DEVIATION REVIEW AND DECISION FORM

Subdivision or Project Name: North Bay at Lake Woodmoor

Section of ECM from which Deviation Is Sought: 2.2.5.E

Deer Creek Road Intersection/Access Spacing Exhibit

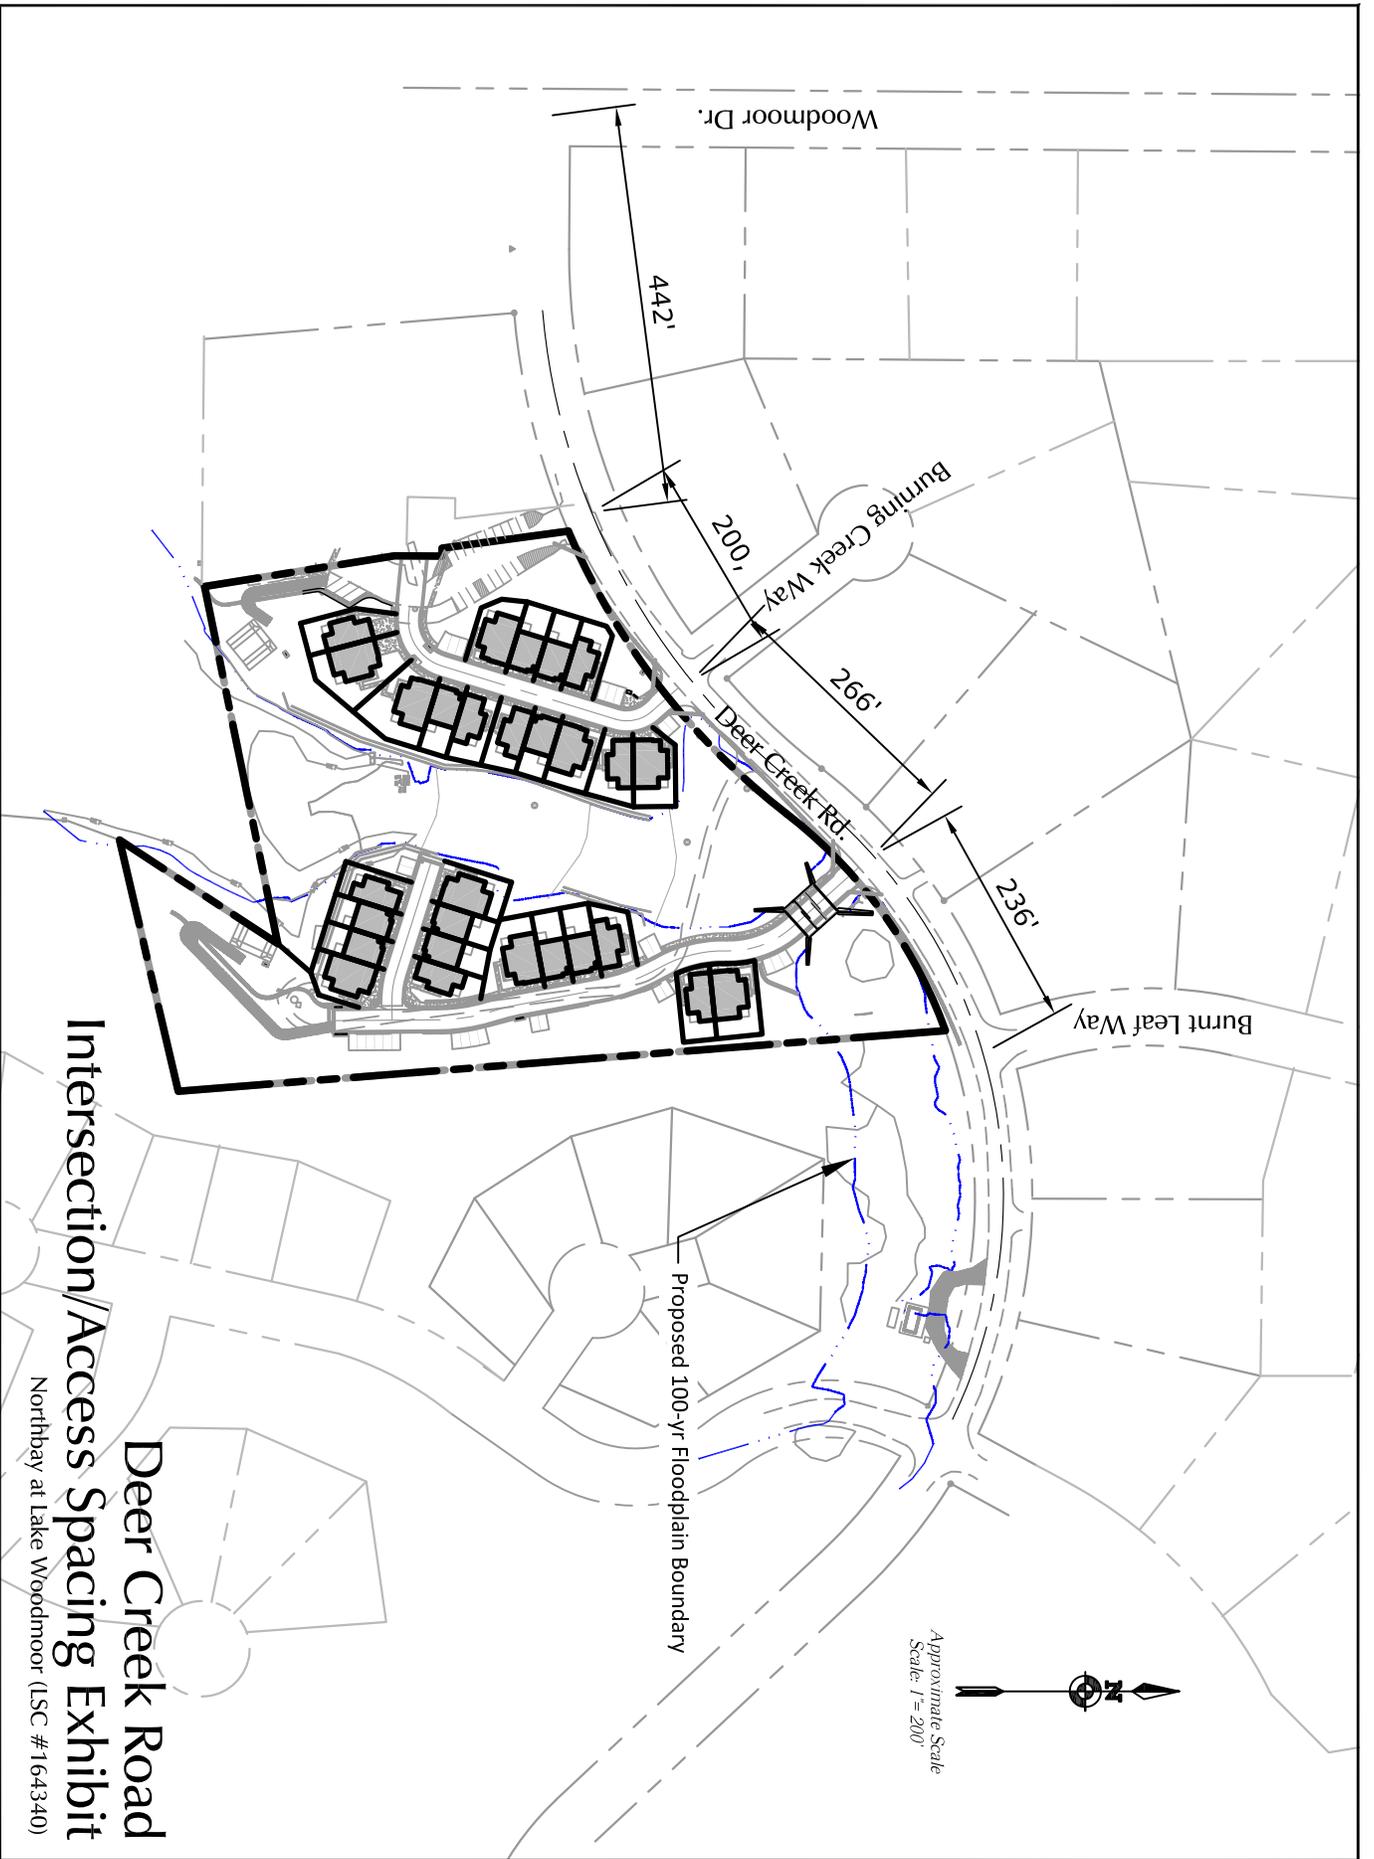
Proposed Nature and Extent of Deviation: Allow access intersection spacing of 265 feet (east from the west site access(proposed)/Burning Oak Way/Deer Creek Road intersection to the proposed east access intersection.

Reason for the Requested Deviation: Floodplain constraints limit the allowable distance between the two proposed access points.

Comparison of Proposed Deviation to ECM Standard: ECM prescribed intersection spacing along a Rural Local road is 330 feet. Proposed intersection spacing is 265 feet.

The deviation is requested to provide access to the east portion of the site via Shoreditch Heights. The east section of the property lies within the 100-year FEMA floodplain and floodway, which constrains the access location.

The proposed spacing will be sufficient and will not adversely affect safety or operations. The proposed spacing will not interfere with existing or proposed auxiliary turn lanes because there are currently none and none are proposed. Also, the stopping sight distance between the access point intersections meets ECM standards.
